DEVELOPMENT CONSENT AUTHORITY
TENNANT CREEK DIVISION

AGENDA ITEM: **1** MEETING DATE: 17/02/2025 FILE: PA2024/0282

APPLICATION: Dwelling – group comprising of x 1 existing single storey dwelling and 2 x 3 bedroom 1 x two storey buildings
APPLICANT/CONTACT: Mary Kingham Bradley
LAND OWNER: Mary Kingham Bradley and Christopher Richards
LOCATION: (73) Ambrose Street, Tennant Creek (**Bookmark A**)
ZONE: LMR (Low Medium Density Residential)
AREA: 715m²

1 Landscape Area Plan
1 : 200

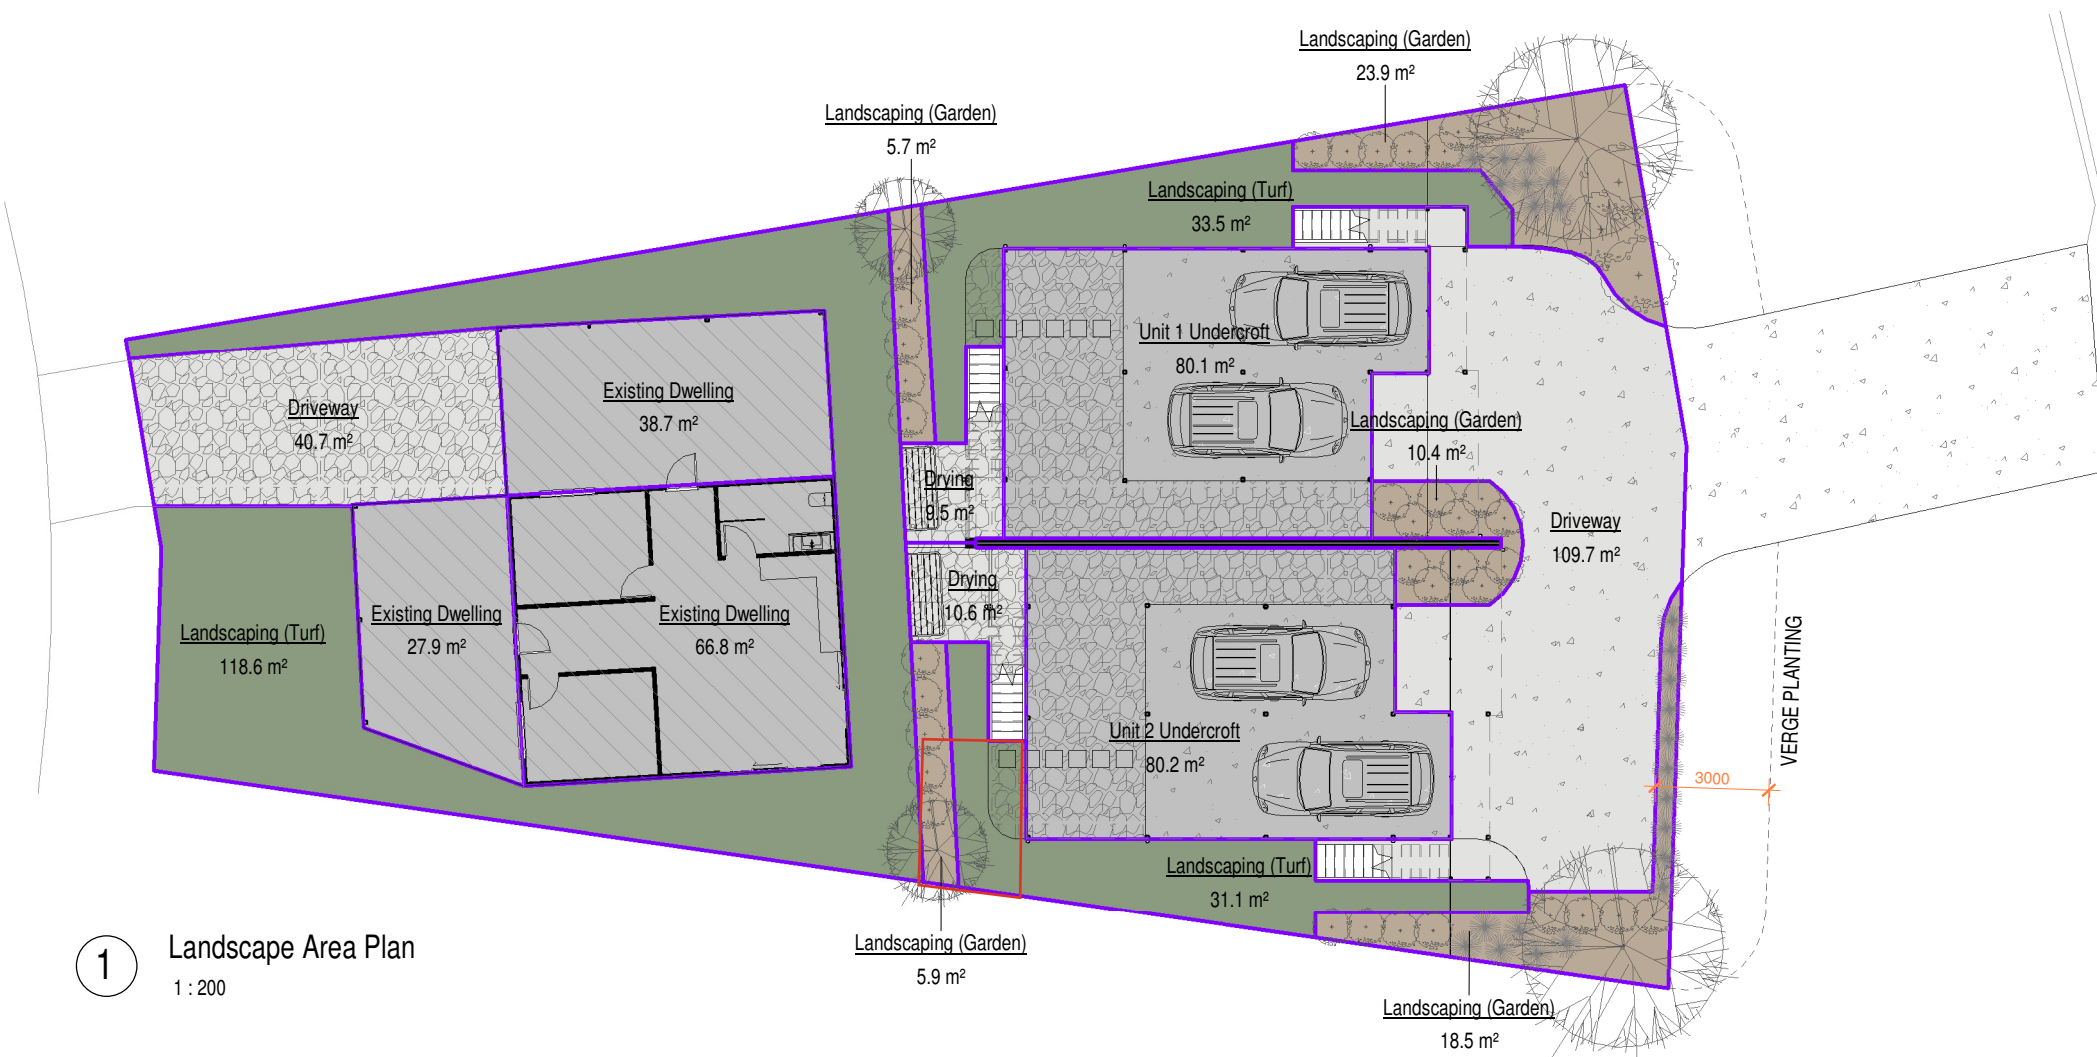
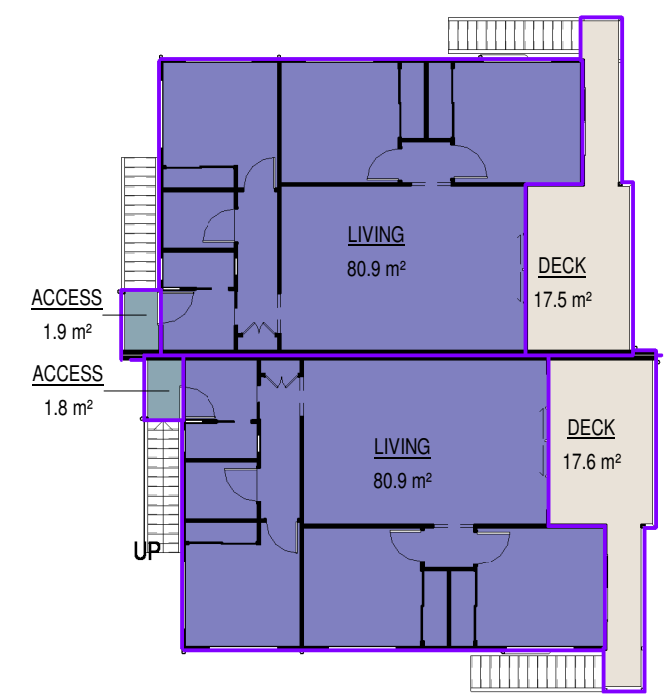
- The functional POS calculation does not include the areas set aside for the laundry clothesline.
 - The allocated POS provides compliant dimensions for the purpose of deep soil planting allowing the 27m² area to be purposed for residential amenity by the occupants.
